# UNITED STATES PATENT AND TRADEMARK OFFICE

APPLICATION NO.	FILING DATE	FIRST NAMED INVENTOR	ATTORNEY DOCKET NO.	CONFIRMATION NO.
10/509,075	09/22/2004	Raoul Donath	008932-1004-999	1247
51832	7590	07/13/2006	EXAMINER	
JONES DAY 222 EAST 41ST STREET NEW YORK, NY 10017-6702			WOODALL, NICHOLAS W	
			ART UNIT	PAPER NUMBER
			3733	
DATE MAILED: 07/13/2006

<b>Office Action Summary</b>	<b>Application No.</b> 10/509,075	<b>Applicant(s)</b> DONATH, RAOUL	
	<b>Examiner</b> Nicholas Woodall	<b>Art Unit</b> 3733

Figure 1

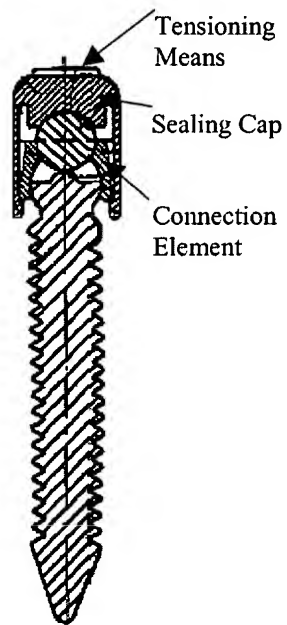
Regarding claim 1, Schaffler-Wachter discloses a device comprising a connection element, a sealing cap, and a tensioning means as shown in Figure 1 below. The connection element, as shown in Figure 2, is arranged coaxially to the central axis with an upper end, lower end, a channel passing through the connection element transversely to the longitudinal axis, and a cavity coaxial to the central axis passing through the connection element from the upper end to the lower end. The cavity is designed tapering towards its lower end by means of at least one shoulder as shown in Figure 3. The sealing cap, as shown in Figure 4, comprises a front end, rear end, a second cavity to receive the connection element, and a second channel transverse to the longitudinal axis. Regarding claim 2, Schaffler-Wachter discloses a device characterized the arresting means of the latching means is arranged on a cross-section surface orthogonal to the central axis on the periphery of the connection element and on the periphery of the second cavity in the sealing cap as shown in Figure 2. Regarding claim 3, Schaffler-Wachter discloses a device characterized in that the arresting means is comprised of a bulge on the external periphery of the connection element and a corresponding recess on the inner periphery of the second cavity in the sealing cap as shown in Figure 3. Regarding claim 4, Schaffler-Wachter discloses a device

Figure 3

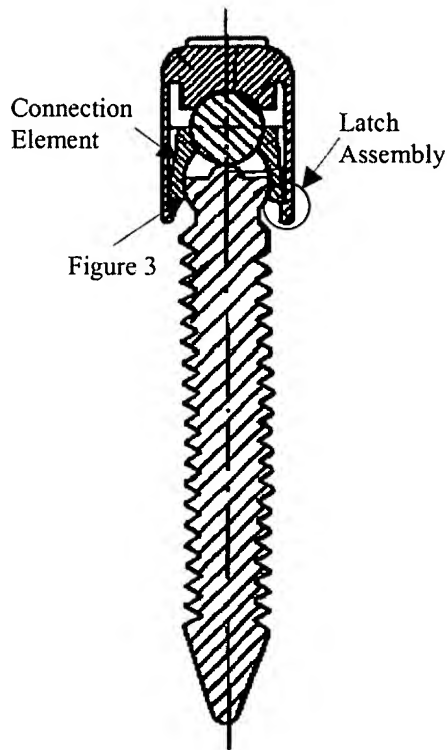
characterized in that the shoulder in the connection element comprises a level-bearing surface of a circular shape concentric to the central axis as shown in Figure 3.
